## General Bid Bulletin No. 30

24 September 2021

### **THE MALOLOS-CLARK RAILWAY PROJECT AND THE NORTH-SOUTH RAILWAY PROJECT SOUTH LINE COMMUTER PACKAGE CP NS-01: PROCUREMENT OF ELECTRICAL AND MECHANICAL SYSTEMS AND TRACK WORKS (IFB No: 21-040-3)**

**PACKAGE CP NS-01: E&M SYSTEMS AND TRACK WORKS**  
**General Bid Bulletin No. 30**  
**Annex A**

### TRANSITION SLAB 2

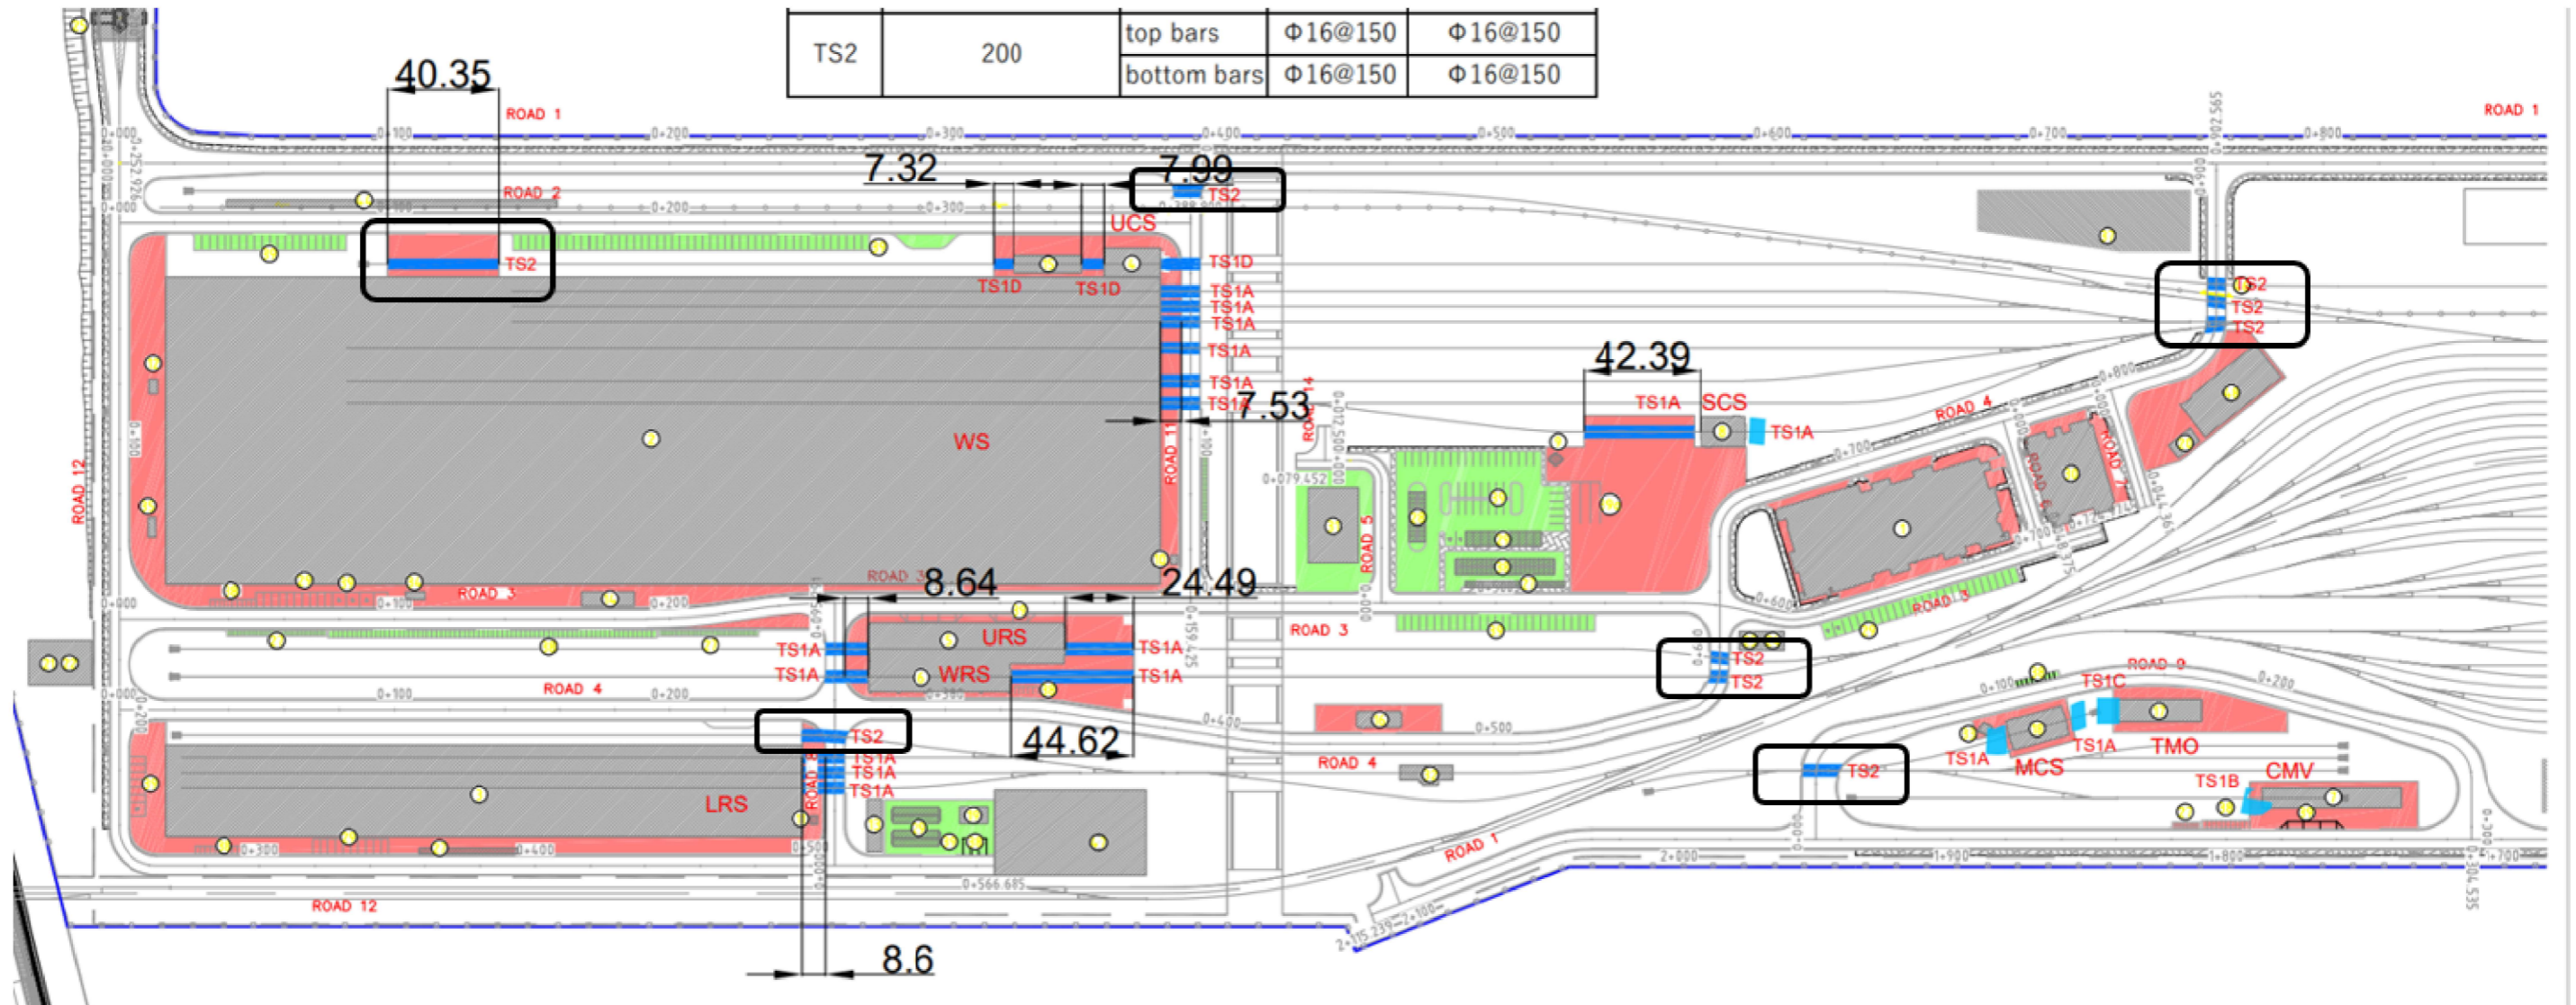
<p>“Coordination during the DED - Location of CCTV Cameras. (As stated above on the Responsible Area of CCTV System.)</p> <p>Identification of CCTV Cameras for their BMS including EAC.”</p>
13	ERT-248- Interface with Civil/ Architecture system.	<p>Deleted Item:</p> <p>“CCTV System installed by Architecture” Section</p>
14	ERT-324: 9) General Coverage	Added: “Perimeter Fence”
<b>Volume III Part 2 – Employer’s Requirements d) Employer’s Drawings</b>		
15	Volume III Part 2- Employers Requirements Drawings (a)	<p>Added a reference drawing regarding Transition slabs.</p> <p>NSCR-GCR-NS01-SWEM-DWG-TK-000001</p> <p>NSCR-GCR-NS01-SWEM-DWG-TK-000002</p>

- 3) In the Depot, the main track structures are ballasted track jointed with short welded rails and fishplates. In the Inspection and Repair bays, the rail is supported on concrete or steel stumps/poles. The Contractor shall provide a track structure in the Workshops and at level crossing in which the top surface of the rail head is flush with the adjacent paved area and the elevation is determined by the rail level. Resilience shall be provided between the rail and the paved area. The contractor shall also provide the transition slabs in the in the depot areas.
